MEMORANDUM FOR: R. Lefnus, Assistant Director for Safety Assessment, NRC
 T. Speis, Assistant Director for Reactor Safety, NRC
 SUBJECT: EVALUATION REPORT ON SEP TOPIC VI-4, CONTAINMENT ISOLATION SYSTEM FOR THE PALISADES NUCLEAR POWER PLANT, UNIT 1 (DOE ID: 54-255) - REVISION 1

Containment Systems Branch
Evaluation Report on SEP Topic VI-4,
Containment Isolation System for the
Palisades Nuclear Plant, Unit 1
Docket No. 50-255
Revision 1

Figure 3

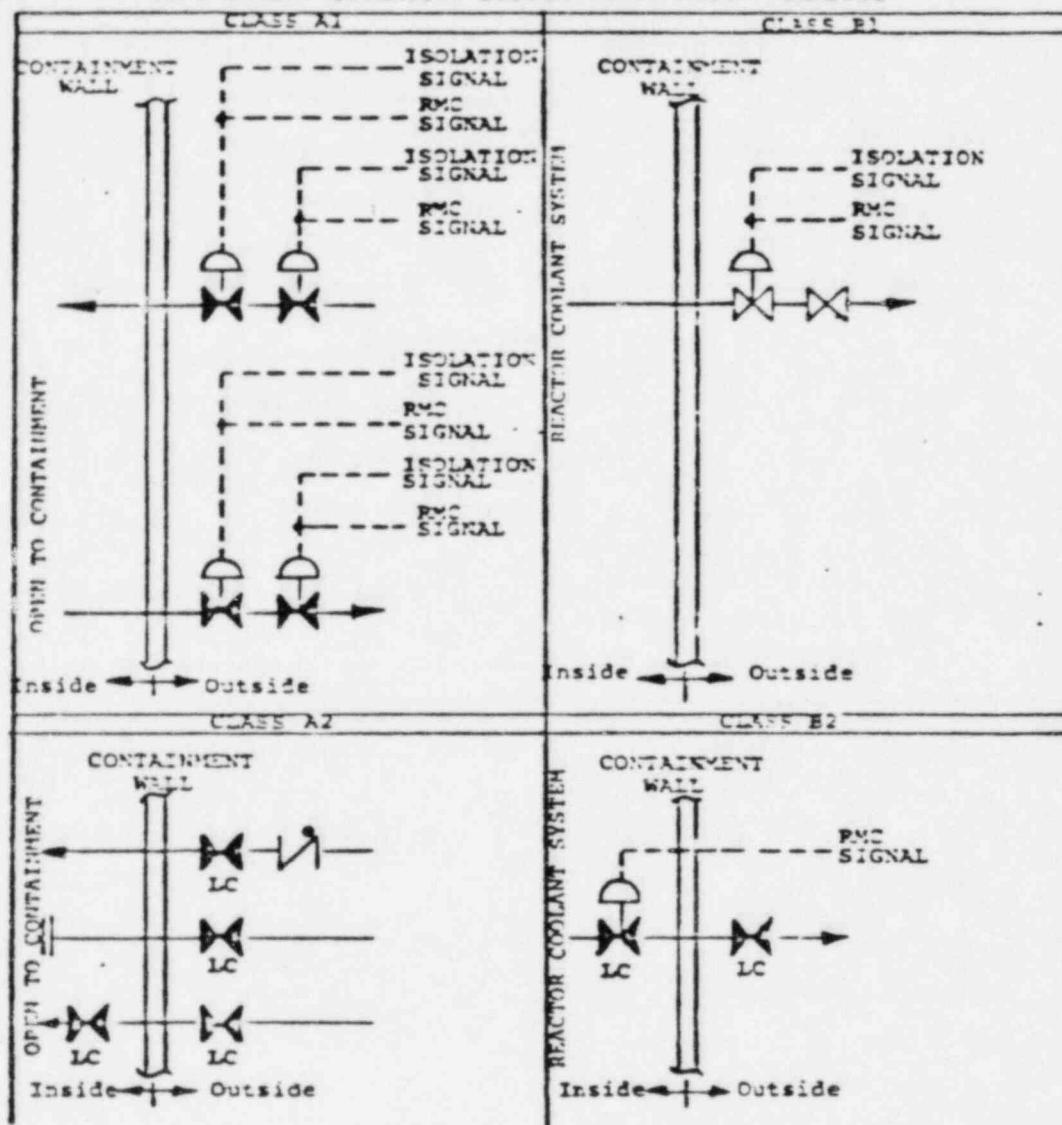
Penetration Class A1 shows influent and effluent lines open to the containment with two isolation valves in series outside containment.

GDC 56 applies to the lines in Penetration Class A1. GDC 56 specifies that one valve should be located inside containment and one valve should be located outside containment. Consequently, the isolation valving arrangement for Penetration Class A1 differs from the explicit requirements of GDC 56 from the standpoint of valve location. Locating both containment isolation valves outside containment may be acceptable if the criteria used in the design of the piping between the containment the first valve are sufficiently conservative to provide adequate assurance of integrity. This matter is discussed under SEP Topic III-1.

Penetration Class A2 shows three isolation configurations that are open to the containment. GDC 56 applies to the lines in Penetration Class A2. One of the isolation configurations (i.e., the line having a locked-closed valve inside containment and a locked-closed valve outside containment) satisfies the explicit requirements of GDC 56. The following containment penetrations have this isolation configuration in Penetration Class A2: 64, 66 and 72.

The isolation configuration having a blind flange inside containment and a locked closed valve outside containment differs from the explicit requirements of GDC 56 from the standpoint of isolation barrier type. GDC 56 does not address the use of blind flanges. However, a blind flange is an acceptable isolation barrier in lieu of a valve. The basis for this appears in SRP 6.2.4 at Item II.3. Also, the locked-closed valve could be an automatic isolation valve and still satisfy GDC 56. The following containment penetrations have this isolation configuration in Penetration Class A2: 18, 18a and 27.

The isolation configuration having both a locked closed valve and a simple check valve outside containment differs from the explicit requirements of GDC 56 from the standpoint of valve location and valve type. GDC 56 specifies that one valve should be located inside containment and one valve should be located outside containment, and that a simple check valve may not be used as an automatic isolation valve outside containment. For this configuration to be acceptable, the check valve should be located inside containment. Also, the locked closed valve could be an automatic isolation valve to satisfy GDC 56.

Penetration Class B1 shows two series isolation valves outside containment in a line coming from the reactor coolant system. As shown, one of the valves is an automatic isolation valve and the other is a normally open, manual valve. Depending on the line, however, a simple check valve or remote manual valve is used. GDC 55 applies to the lines in Penetration Class B1. GDC 55 specifies that one valve should be located inside containment and one valve should be located outside containment, with the valves being either locked closed or automatic isolation valves.

The isolation valving arrangement for Penetration Class B1, therefore, differs from the explicit requirements of GDC 55 from the standpoint of valve location, type, and actuation. Locating both isolation valves outside containment may be acceptable if piping and valve design criteria are sufficiently conservative to preclude a breach of integrity. This matter is

discussed under SEP Topic III-1. The use of a local manual valve for containment isolation is not acceptable, and should be upgraded to an automatic isolation valve.

Penetration Class B2 shows a locked closed valve inside containment and a locked closed valve outside containment in a reactor coolant system effluent line. GDC 55 applies to the lines in Penetration Class B2. The isolation arrangement satisfies the explicit requirements of GDC 55.

Penetration Class C1 shows two types of valve arrangements for closed systems inside containment that are missile protected; namely, a single simple check valve outs te containment for influent lines and a single automatic isolation valve outside containment for effluent lines. GDC 57 applies to the lines in Penetration Class C1. GDC 57 specifies that a single automatic, remote manual or locked closed isolation valve outside containment is acceptable, but a simple check valve is not an acceptable automatic isolation valve. The isolation valve arrangement having a

single simple check valve outside containment differs from the explicit requirements of GDC 57 from the standpoint of valve type.

Penetration Class C2 shows isolation valve arrangements for influent and effluent lines of closed systems inside containment that are not missile protected. The valve arrangements consist of two valves in series, outside containment.

GDC 56 applies to the lines in Penetration Class C2. GDC 56 specifies that one automatic or locked closed valve should be located inside containment and one such valve should be located outside containment; also, a simple check valve may not be used as an automatic isolation valve outside containment.

The valve arrangements of Penetration Class C2 differ from the explicit requirements of GDC 56 from the standpoint of valve location and valve type. All valve arrangements would satisfy the explicit requirements of GDC 56 if one valve was located inside containment, particularly the simple check valve.

GDC 56 permits isolation valve arrangements that differ from the explicit requirements provided the basis for acceptability is defined. With respect to Penetration Class C2, then, locating both isolation valves outside containment may be acceptable since missile protection is not provided inside containment. The acceptability of this is contingent on the criteria used in the design of the piping between the containment and first valve, and the first valve, which must provide adequate assurance of integrity.

Penetration Class C3 shows two, locked closed isolation valves in series, outside containment, for effluent lines from systems that are closed inside containment and not missile protected. GDC 56 applies to the lines in Penetration Class C3. The valve arrangements described above differs from the explicit requirements of GDC 56 from the standpoint of valve location, namely, one valve should be located inside containment. However, locating both valves outside containment may be acceptable, based on the discussion under Penetration Class C2.
